## Modification to run CPU09CMI on 5MHz bus.

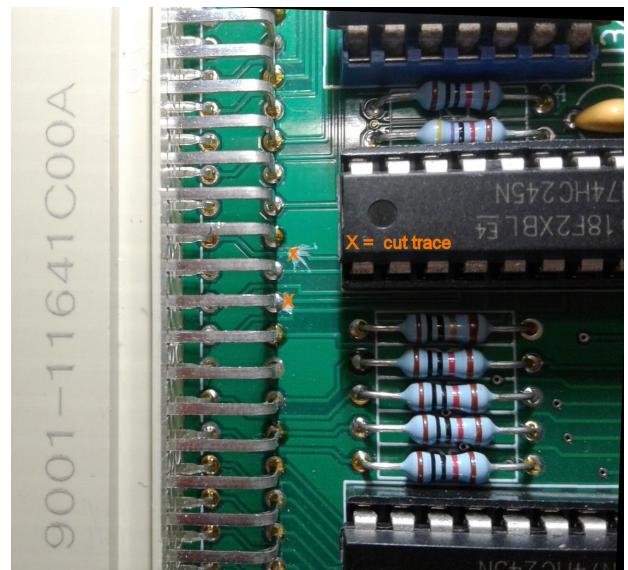
Replace xtal into 20MHz.

Replace C1 and C2 by 15pF.

Place 10M smd between crystal pins.

Replace GAL CMI\_1 by CMI-4\_1

Only use the HD63C09.

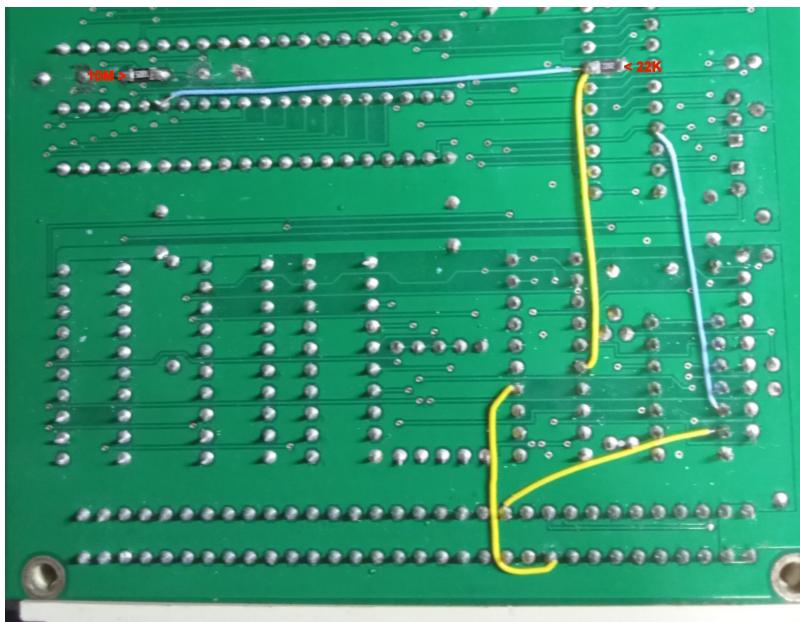
Cut trace between U4-14 and J1 C-21 (B\_VMA-)

For REV:0.9 print only cut trace from J1 A23 to R15

Cut trace between U13-19 and via (OVMA-)

Place 22K resistor between U13-19 and Gnd

Place wire from U6-35 to U13-19 (blue) and U4-6 (Q) (yellow)

Place wire from U4-14 to J1 A-23 (B\_Q) (yellow)

Place wire from U3-7 to J1 C-21 (B\_VMA-) , **Or:**
